New Reactors Division – Generic Design Assessment

**Step 4 Assessment of Radiological Protection and Criticality for the UK HPR1000
Reactor**

Assessment Report ONR-NR-AR-21-022
Revision 0
January 2022

Figure 4: Graph comparing the collective worker dose for PWRs globally (Ref. 84).

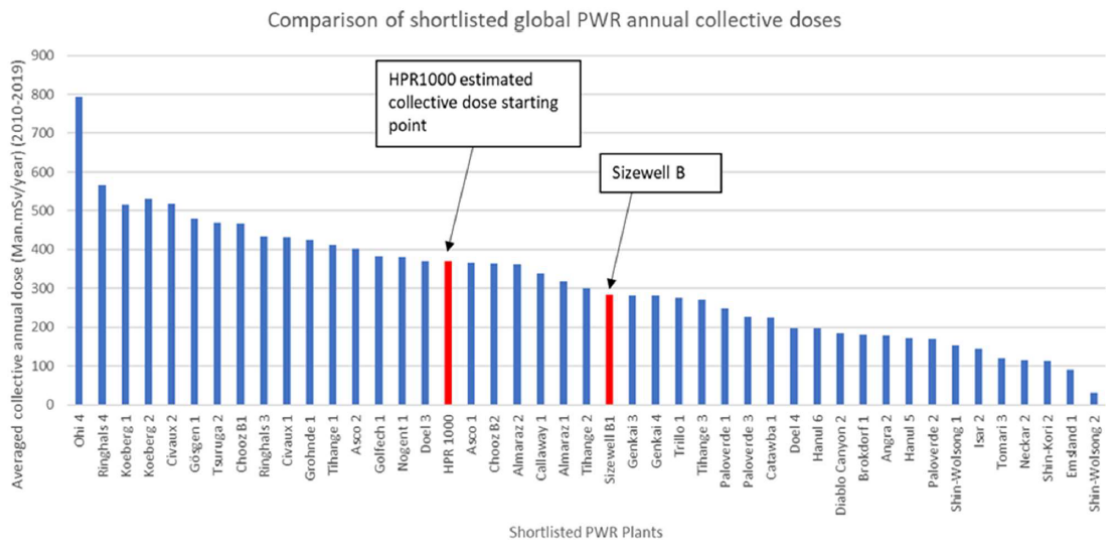
184. From figure 4, the initial worker collective dose for the generic UK HPR1000 design is comparable with other PWRs around the world. Although the generic UK HPR1000 design has a slightly higher worker collective dose than Sizewell B, the predicted collective worker dose for generic UK HPR1000 design is lower than the EPR™ (Ref. 98). This does not consider further worker dose optimisation which is discussed later on in this section.
